Commission of Architectural Review

8. COA-167745-2025	Conceptual Review	Meeting Date: 6/24/2025
Applicant/Petitioner	Christopher Raynore	
Project Description	Construct a two-story single-family residence on a vacant lot	
Project Location		
Address: 520 Brook Road		
Historic District: Jackson Ward		
<p>High-Level Details:</p> <p>The applicant proposes new construction of a small, two-story single-family residence with basement and rooftop terrace at 520 Brook Road, located within the Jackson Ward Old and Historic District. The lot is triangular and limited in buildable area.</p> <p>The proposed infill building uses cementitious siding, vertically aligned windows, and a simple form with a modern interpretation.</p> <p>The project will require a Special Use Permit.</p>		
Staff Recommendation	Approval, with Conditions	
Staff Contact	Yara Iwaz, Yara.Iwaz@RVA.gov, (804)646-6031	
Previous Reviews	<ul style="list-style-type: none"> N/A 	
Staff Recommendations	<p>Staff finds that the application proposes an infill design that is appropriate for the highly constrained site parameters, and recommends the following modifications and clarifications to better align with the character of the His

2 SOUTHEAST ELEVATION
1/4" = 1'-0"

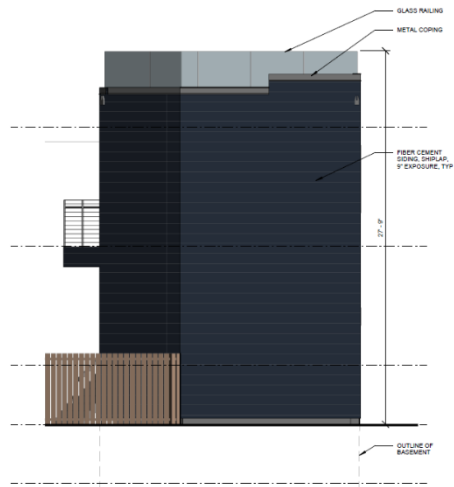
Standards for New Construction: Height, Width, Proportion & Massing, page 47	<i>2. New residential construction should respect the vertical orientation typical of other residential properties in surrounding historic districts. New designs that call for wide massing should look to the project's local district for precedent.</i>	<p>The overall massing is compact and vertical in orientation, which is compatible with the neighborhood, and appropriate given the narrow lot and the scale of surrounding buildings.</p> <p>However, the primary façade lacks the definition and hierarchy seen in historic buildings, particularly a defined entry base.</p> <p>However, the primary elevation currently lacks the architectural hierarchy typically found in contributing residential buildings in the Historic District. In particular, the absence of a defined base weakens the visual organization of the façade.</p> <p><u>To strengthen the building's relationship to the streetscape, Staff recommends introducing a more prominent base-middle-top articulation on the front elevation; define entry feature more clearly with a stoop, recess, or canopy.</u></p>

<p>adjacent blue-painted brick building at 522 Brook Road and the black-trim details of 516 Brook Road.</p> <p>However, the proposed main entry features a full-height glass door with no projection or recess, which diminishes pedestrian engagement. The absence of human-scale design elements or entry differentiation is inconsistent with the pedestrian-focused orientation typical of Jackson Ward. <u>Staff recommends that the entry be enhanced through the introduction of architectural detailing that would create a clearer transition between public and private space.</u></p>
Standards For New Construction: Doors and Windows, p.56	<i>2. The size, proportion and spacing patterns of door and window openings on free-standing new construction should be compatible with patterns established in the district</i>	<p>In historic residential architecture, it is common to find two distinct types of entrances: a prominent, formal entry elevated from the street with a stoop, portico, or canopy that signals the main living entrance to the public realm, and a more utilitarian side or rear entrance serving secondary functions (like access to kitchens or basements). These differentiated entry types reinforce the hierarchy and pedestrian orientation of the façade. In this proposal, this pattern appears to be reversed: the primary street-facing entrance is a utilitarian door flush at grade without articulation, while the actual main living entrance is tucked away in an alley behind a gate.</p> <p><u>Staff recommends reversing this functional hierarchy, by positioning the main entrance on the primary façade with a defined stoop or entry feature that engages the street, and relocating the secondary door to a less prominent side or rear location.</u></p>
